ADDENDUM NO. 1

Request for Quotations (RFP) –Longview Pharmacy

BUILT IN WORKSTATIONS

Project Name: Cowlitz Indian Tribe Longview Pharmacy
Aetta Project #: 25065
Date: 05/29/2026

A201

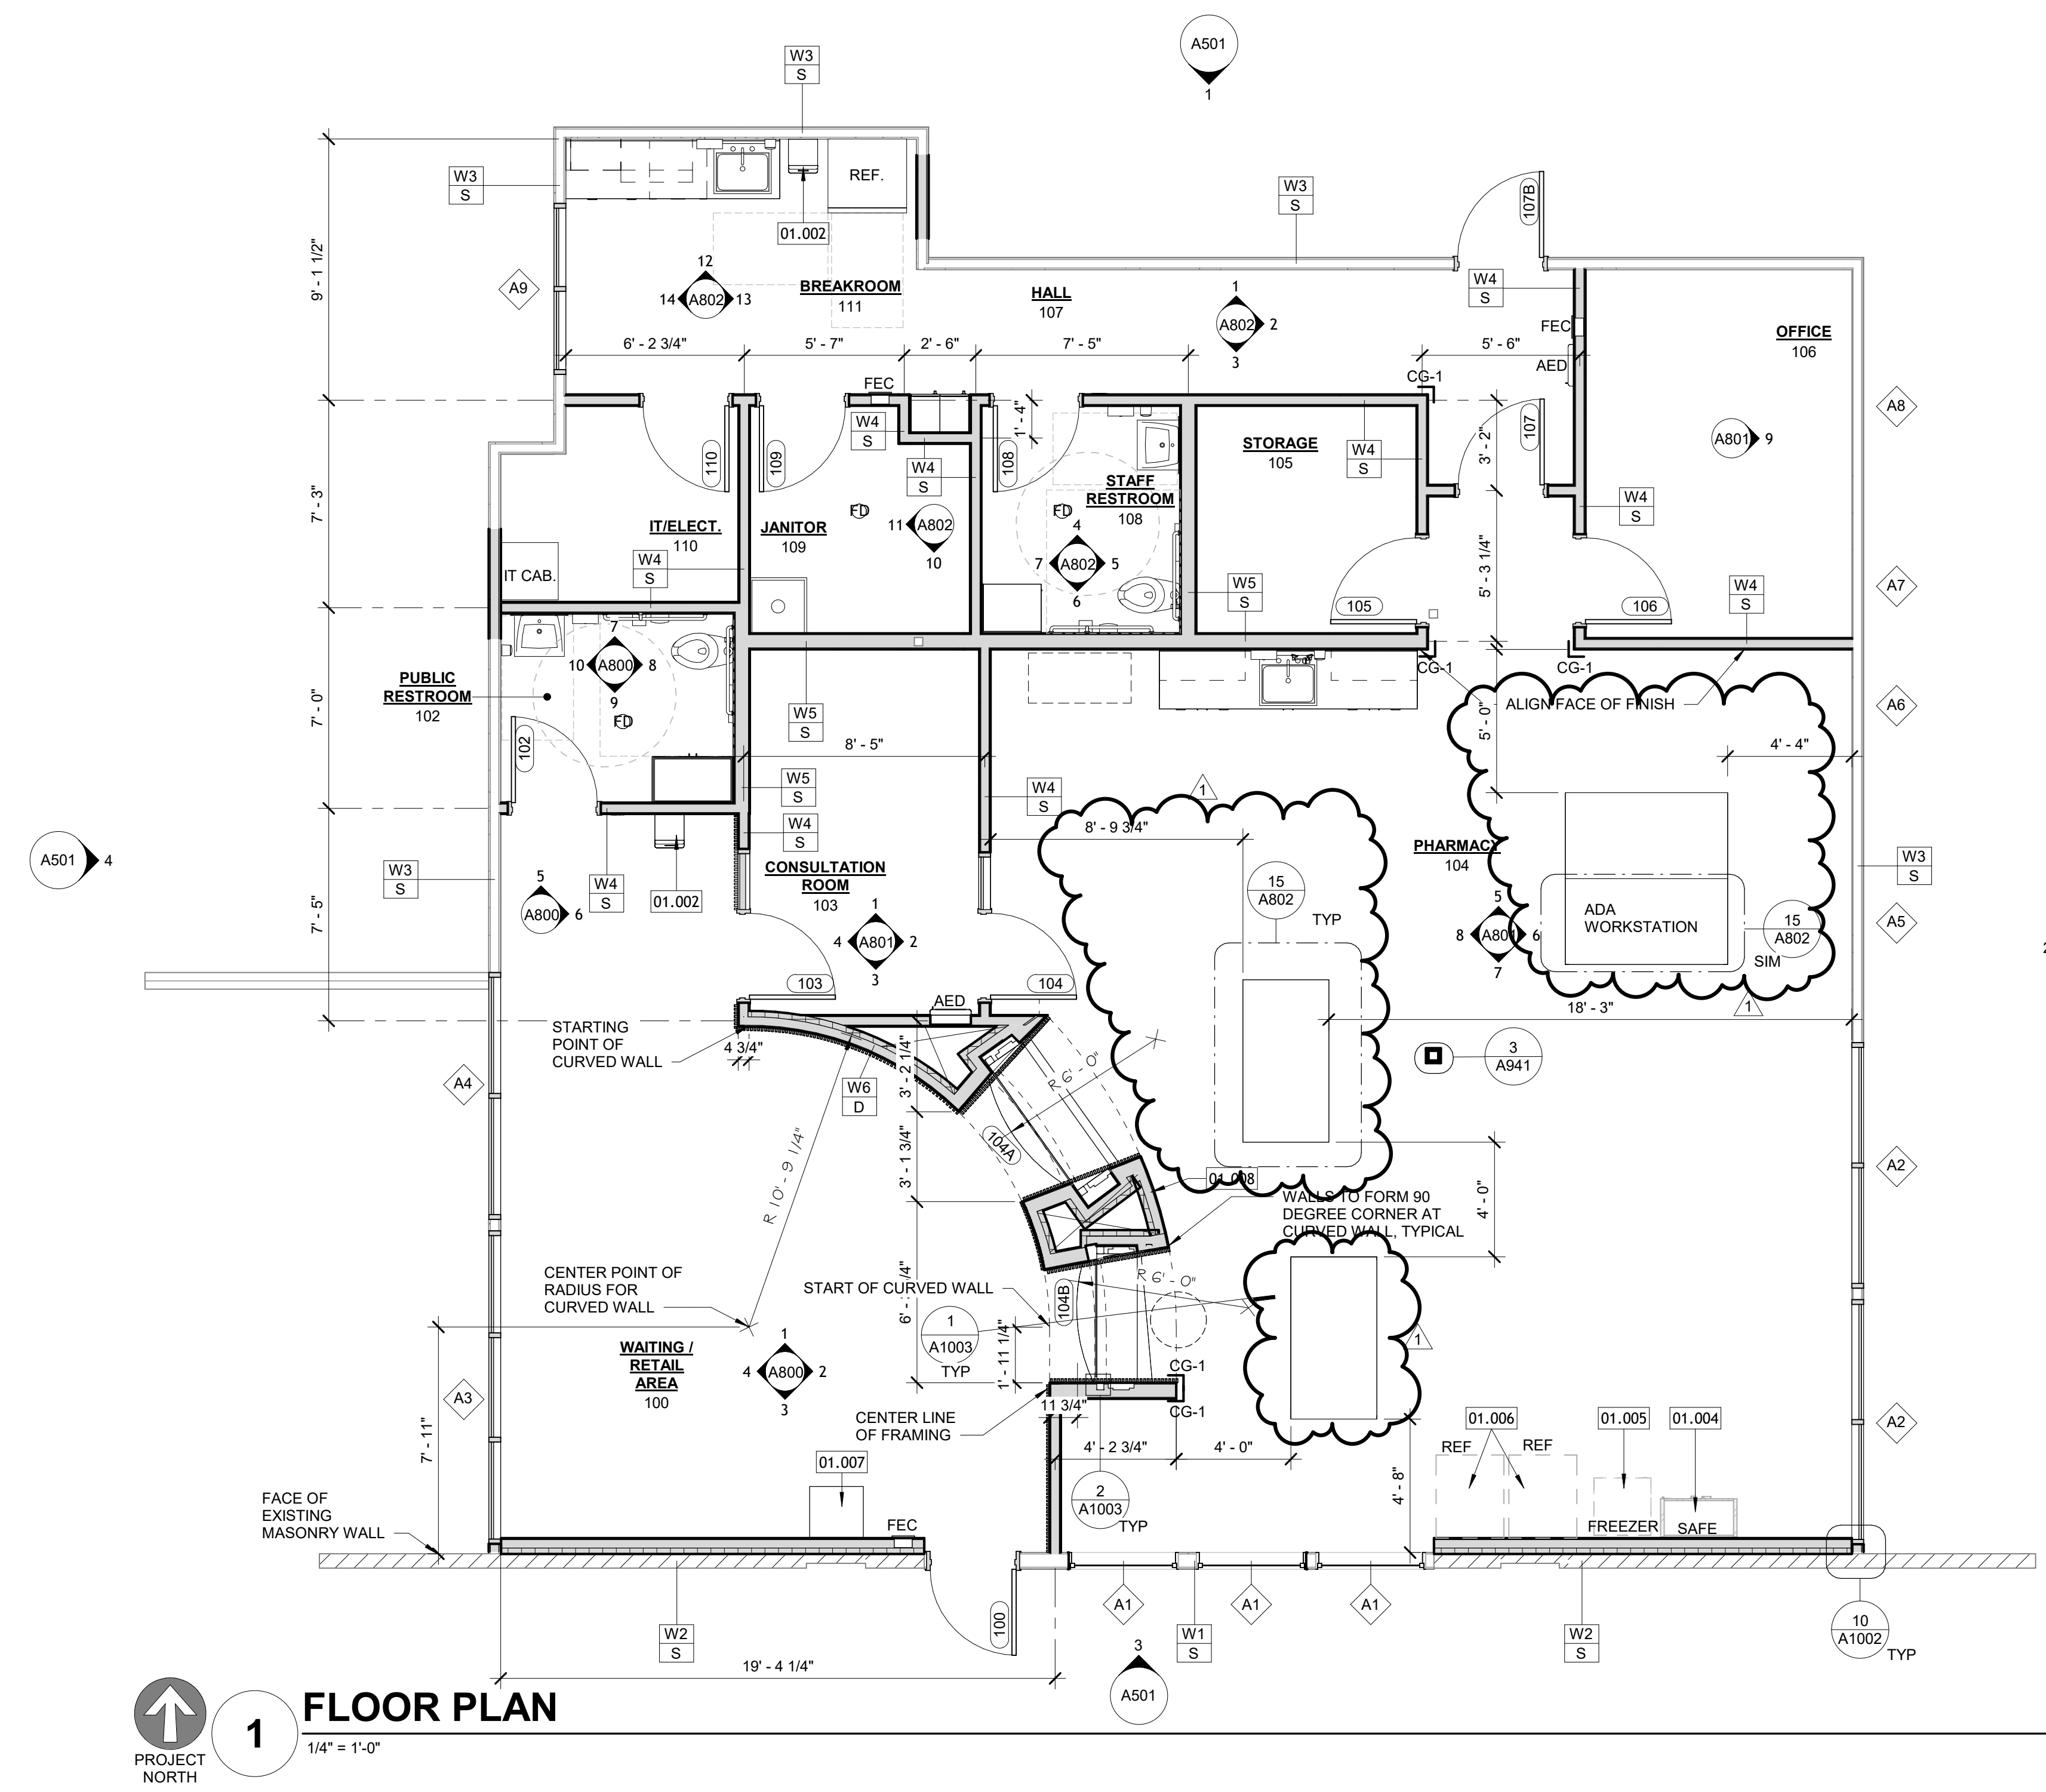
Item #:	Sheet/Detail:	Description:
1.02	A201	REVISED sheet to include built in workstations
1.03	A801	REVISED interior elevation 5
1.04	A802	REVISED interior elevation 12
1.05	A802	ADD views 15-19
1.06	A951	ADD detail 11
